Subject: Final Corrective Measures/Feasibility Study Work Plan
PG&E Topock Compressor Station, Needles, California

Corrective Measures/Feasibility Study Work Plan

Appendix A
Response to Agency Comments on the Draft
Topock Corrective Measures/Feasibility Study
Work Plan

FIGURE 7-1
TOPOCK CORRECTIVE MEASURES/
FEASIBILITY STUDY SCHEDULE
PG&E TOPOCK COMPRESSOR STATION
NEEDLES, CALIFORNIA
CH2MHILL

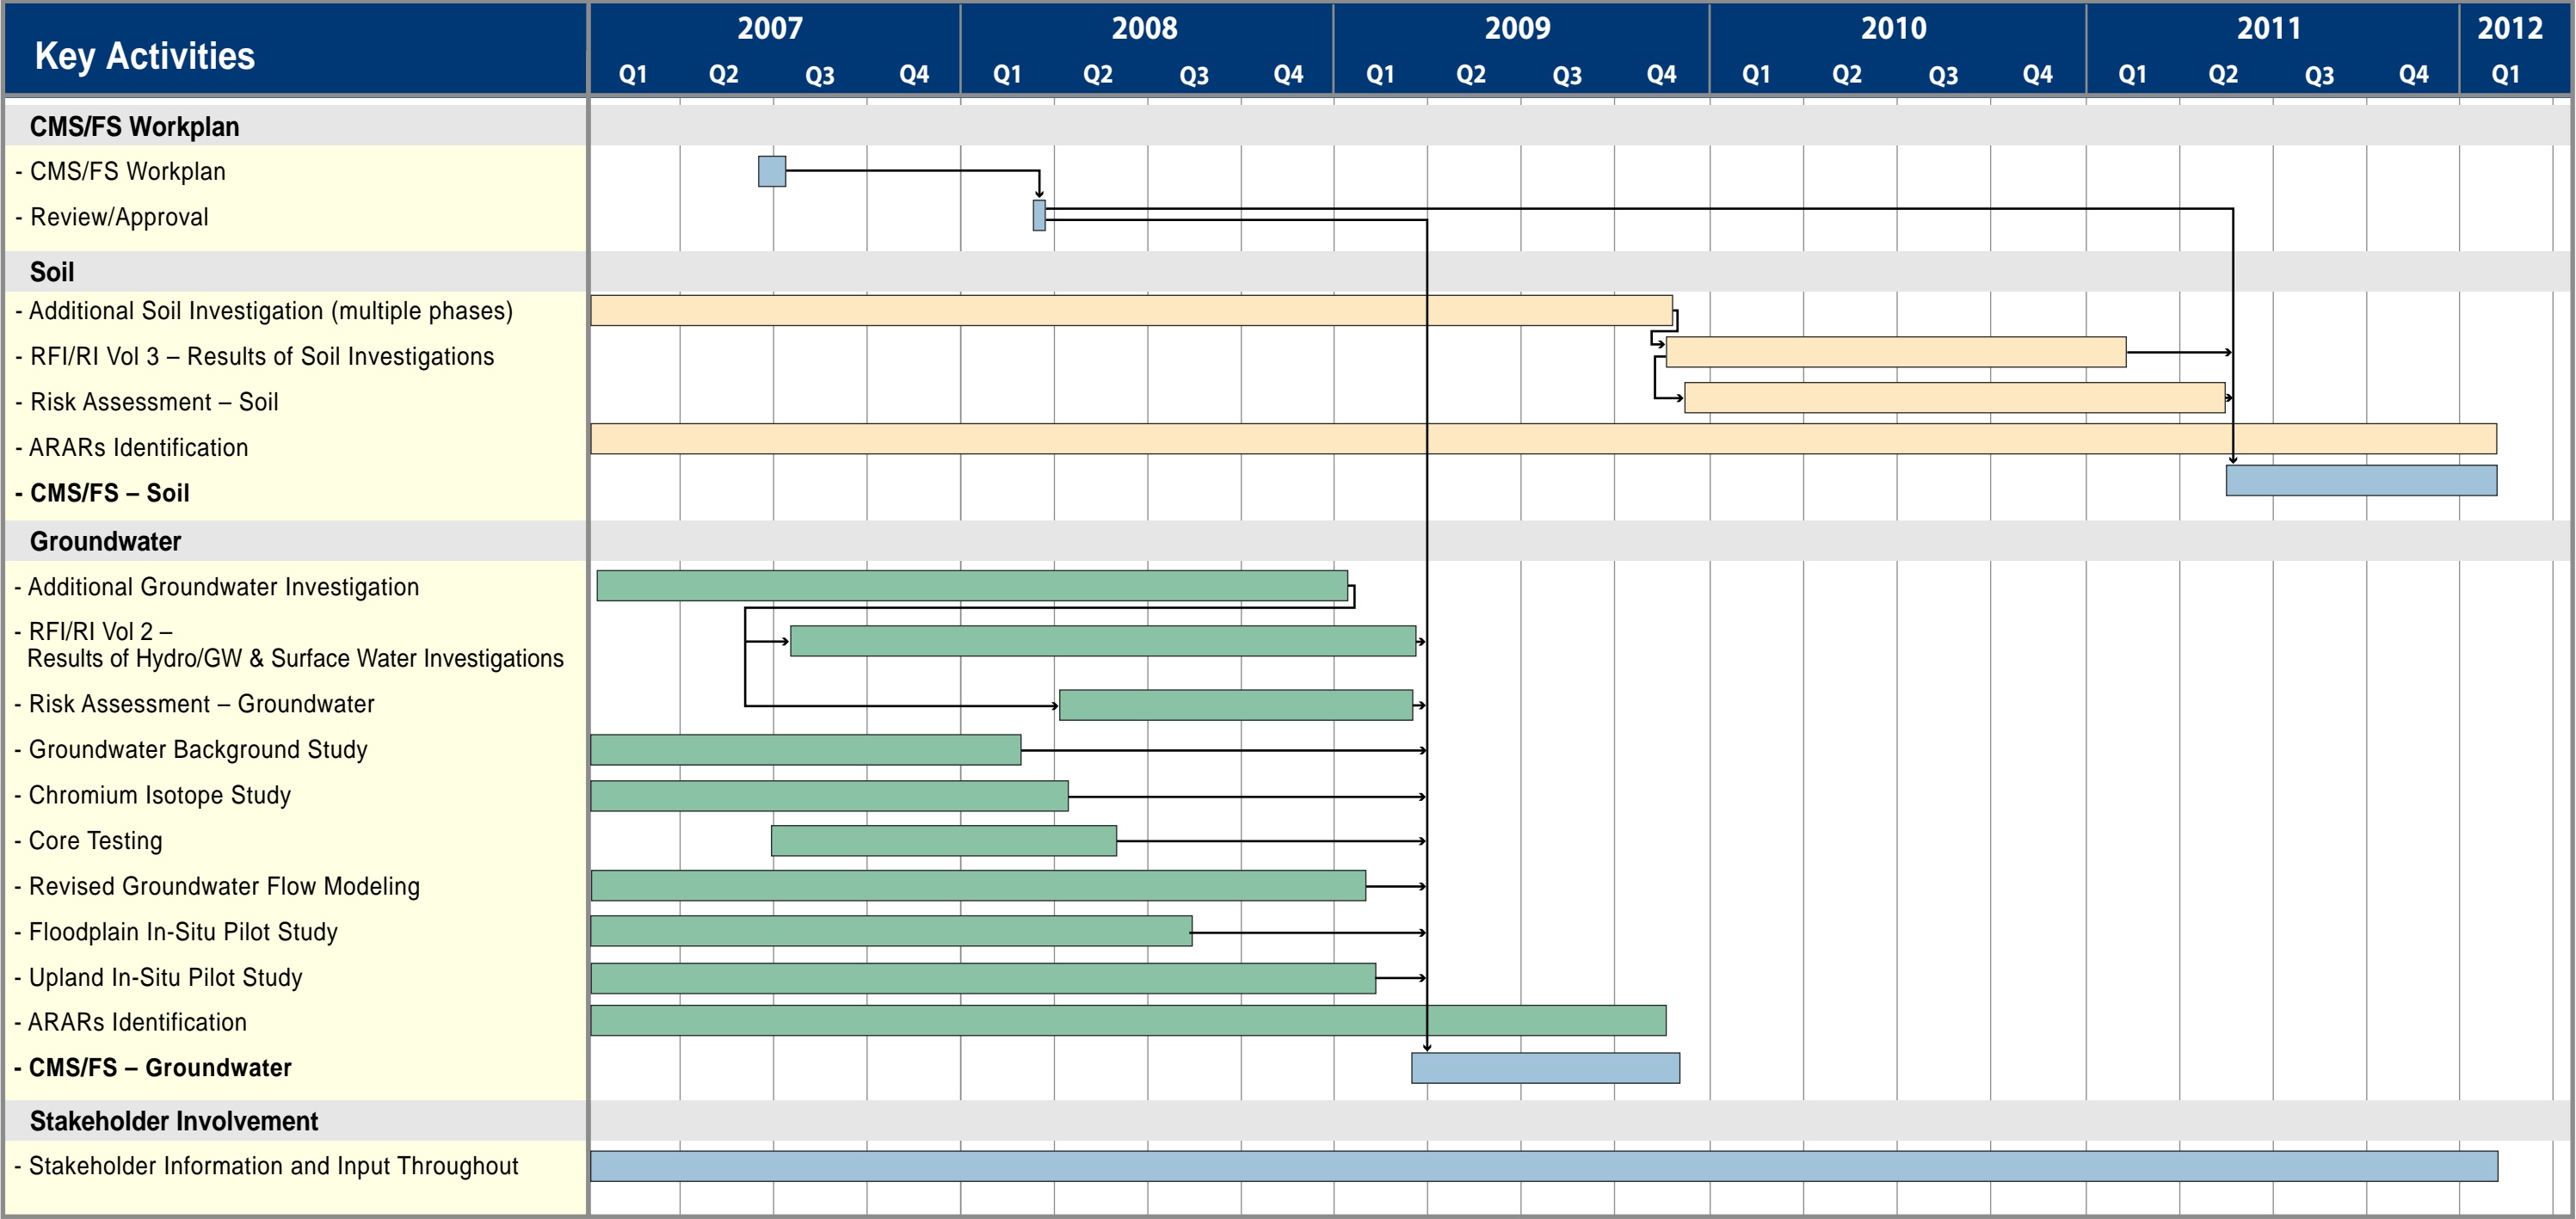
Section 7							
Department of Toxic Substances Control	DTSC-23	Figure 7-1	Since the submission of the CMS/FS Work Plan, a revised base line for the project schedule has been proposed. DTSC requests PG&E to revise the included schedule to follow the new base line schedule. Also, some of the key activities are unclear in the CMS Work Plan schedule. For example, what is meant by “Additional Soil Investigation?” Why did it start before Q1 2007?	It is acknowledged that the baseline schedule has changed since submission of the CMS/FS work plan. The additional soil investigations are to supplement the existing soil data sets for completion of the RFI/RI. Preparation of work plans for the additional soil investigation began in the spring of 2006.			No DTSC or DOI direction to modify the CMS/FS work plan in response to this comment. The schedule in Figure 7-1 has been updated to correspond to the most recent project schedule.

Agency	Comment Number	Section	Comment	Response	DOI Direction	DTSC Direction	Work Plan Revisions
Hargis + Associates, Inc. (on behalf of the Fort Mojave Indian Tribe)	H+A-12	Project Schedule	Based on the June 20, 2007, meeting of the project's CWG, the Tribe understands that separate CMS/FS documents are being prepared for the soils and the groundwater operating units (OUs). This is also reflected on Figure 7-1. According to this schedule, this work plan will be completed during the third quarter (Q3) of this year (2007). Work on the soils CMS/FS will be performed beginning in Q4 2009 and ending during Q1 2011, whereas the groundwater CMS/FS work will begin during Q1 2009 and end during Q4 2009. The Tribe understands that at this time, this division appears to be an appropriate strategy in the interest of schedule efficiency. At the same time, there needs to be some level of awareness with regard to potential relationships between the two OUs. For example, in the soils work plan the issue of continuing sources of groundwater contamination was raised. If indeed this condition were present, would it be dealt with in the context of the groundwater remedy or the soil remedy or both? The screening of various remedial technologies would then need to account for such potential media interactions. Perhaps another example would be that various groundwater remedies may have surface facilities (e.g., wells, pipelines, etc.). The siting of such facilities might need to account for the location soil contamination areas. Basically, the Tribe would generally support the decoupling of the CMS/FS documents for the two OUs, but cautions that PG&E should remain aware of the potential need to address interactions between the two media.	It is acknowledged that the baseline schedule has changed since submission of the CMS/FS work plan. PG&E is aware of the potential relationships between the two operable units and is committed to thoroughly addressing such aspects of the project. It should be clarified that the separation is not strictly between groundwater and soil. • RFI/RI Volume 2 is intended to focus on the characterization of groundwater, surface water, and pore water from PG&E's historic operational practice of wastewater discharge to Bat Cave Wash and PGE-8. The resulting "Groundwater" CMS/FS will address those COCs, media, and pathways identified through the conclusions of RFI/RI Volume 2 and associated risk assessment as requiring remedial alternative evaluation in a CMS/FS. It is expected that the dominant media for alternative evaluation in this CMS/FS will be groundwater. • RFI/RI Volume 3 is intended to focus on the remaining historical Topock Compressor Station operations—as well as other media associated with Bat Cave Wash—and will largely focus on soil but will also include groundwater data from wells within and immediately surrounding the Topock Compressor Station. The resulting "Soil" CMS/FS will address those COCs, media, and pathways identified through the conclusions of the RF/RI Volume 3 and associated risk assessment as requiring remedial alternative evaluation in a CMS/FS. It is expected that the dominant media for alternative evaluation in this CMS/FS will be soil.		PG&E has yet to properly identify the "operable units." To properly respond to the comment, PG&E should define the extent and boundaries of each remedy.	Additional language has been added to Section 7.0 to describe the anticipated extent and boundaries of each remedy. In addition, the schedule in Figure 7-1 has been updated to correspond to the most recent project schedule.
